SERVICE NO. 1093B LETTER

ELECTRICAL CONTACTOR REPLACEMENT KIT

SL 1093B includes revised instructions in which the contactor replacement kit for some models has changed.

KIT ~ ELECTRICAL
CONTACTOR REPLACEMENT

SECTION II: IDENTIFYING OLD vs REPLACEMENT CONTACTOR

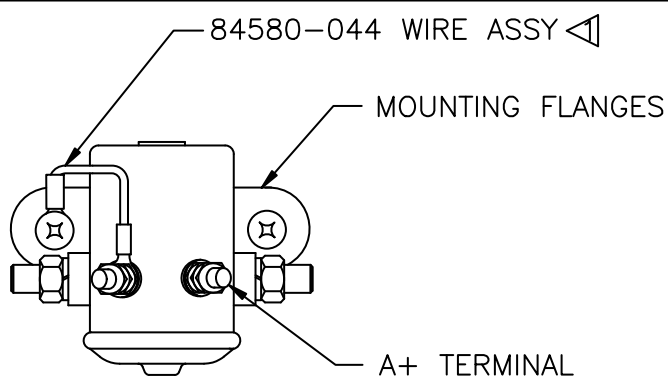
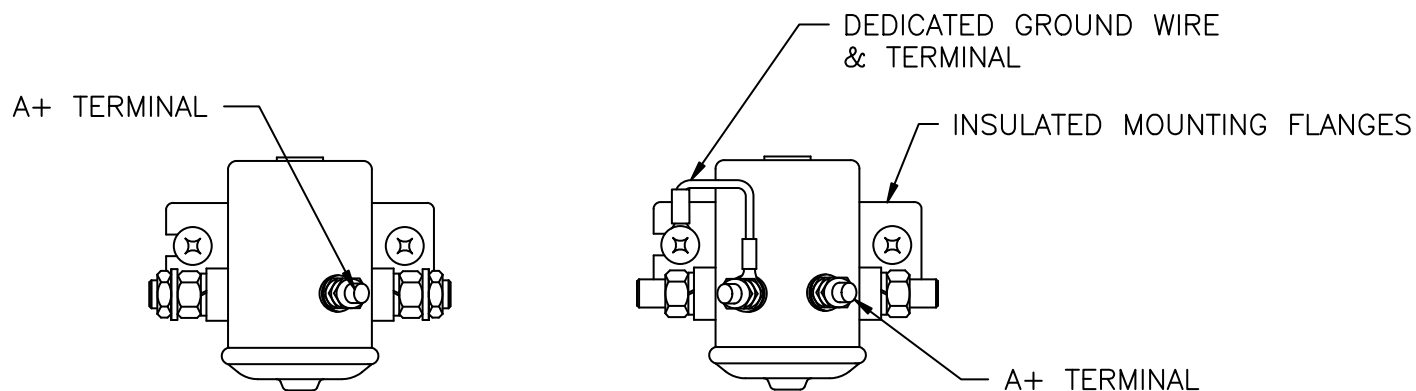
Ⓔ LAMAR CONTACTOR

OLD CONTACTOR

REPLACEMENT CONTACTOR

VIEW A (CONTINUED)

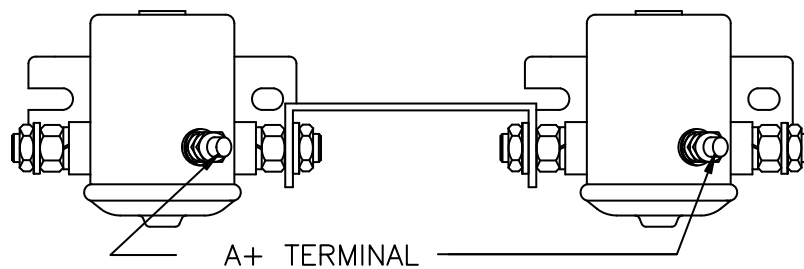
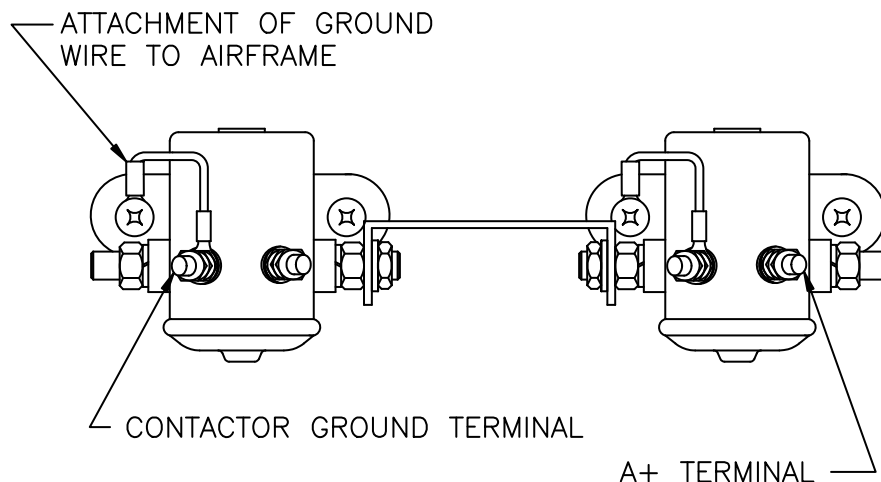
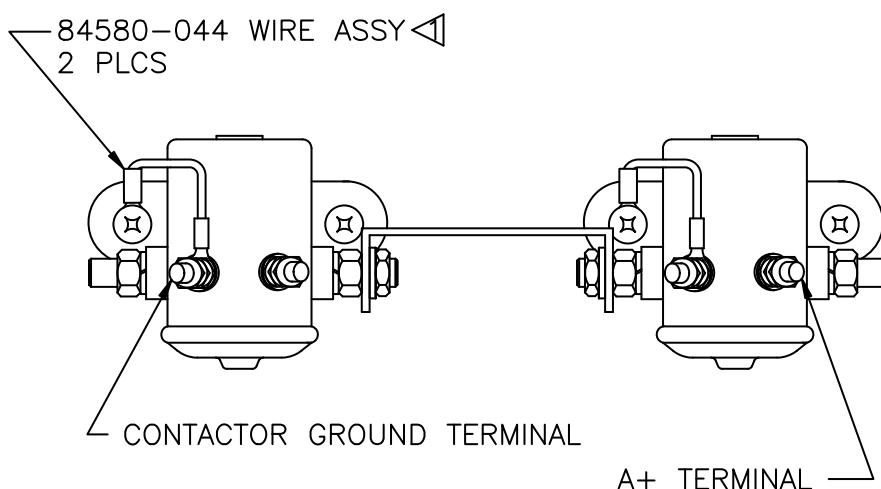
See View A for attachment of Ground Wire to airframe ground.

VIEW B

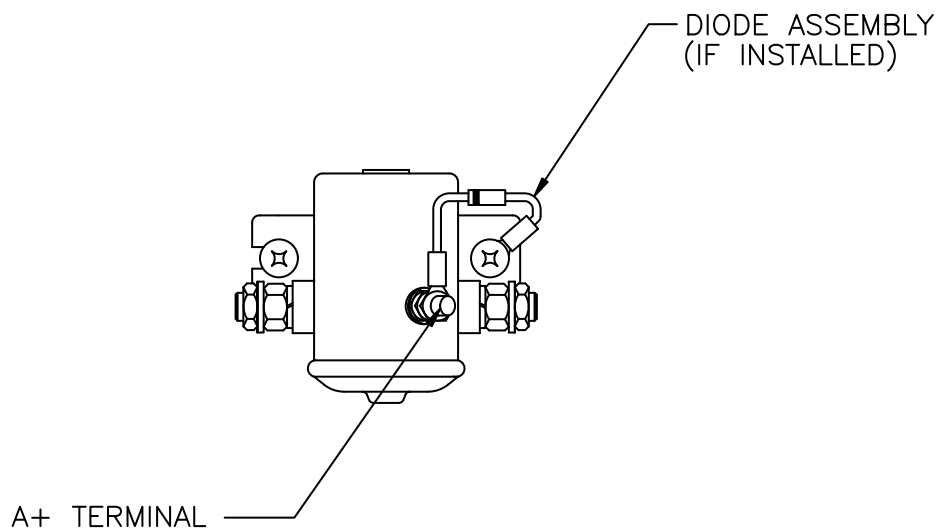
1.2.b. See View B for attachment of Ground Wire to airframe ground for the following aircraft.

If the existing contactor installation includes a diode assembly installed between the A+ terminal on the contactor and the airframe ground, the diode must be reinstalled on the replacement contactor. Confirm that ID band (cathode) on the diode is towards the A+ terminal.

VIEW B (CONTINUED)

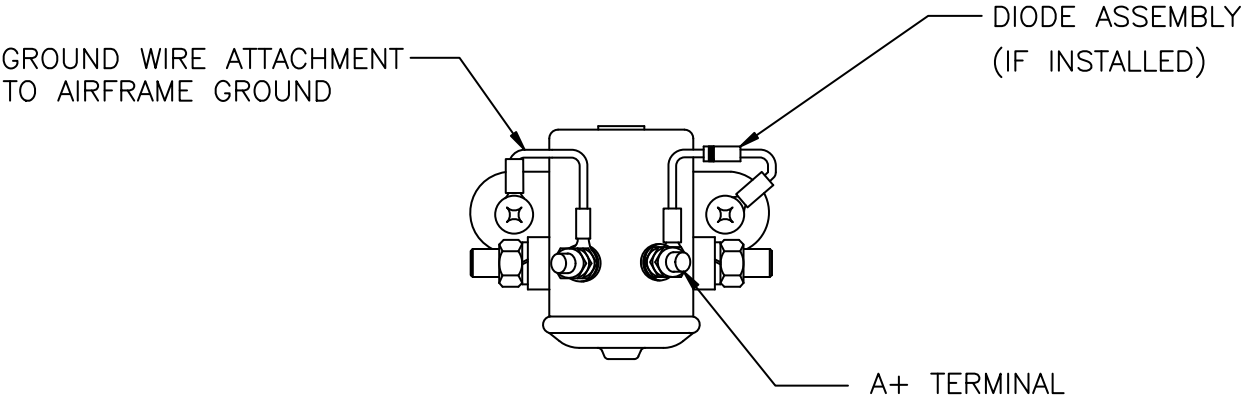
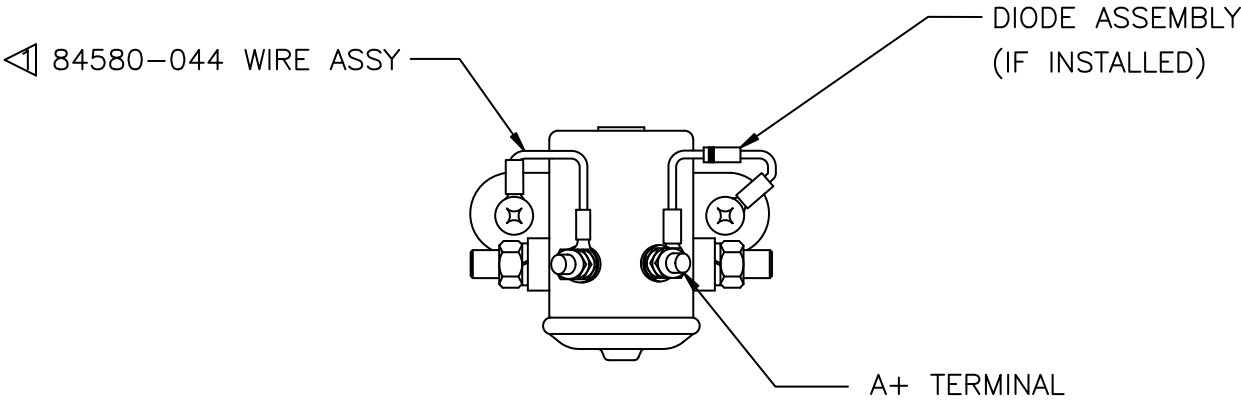
NOTE:
If the existing contactor installation includes a diode assembly installed between the A+ terminal on the contactor and the airframe ground, the diode must be reinstalled on the replacement contactor. Confirm that ID band (cathode) on the diode is towards the A+ terminal.
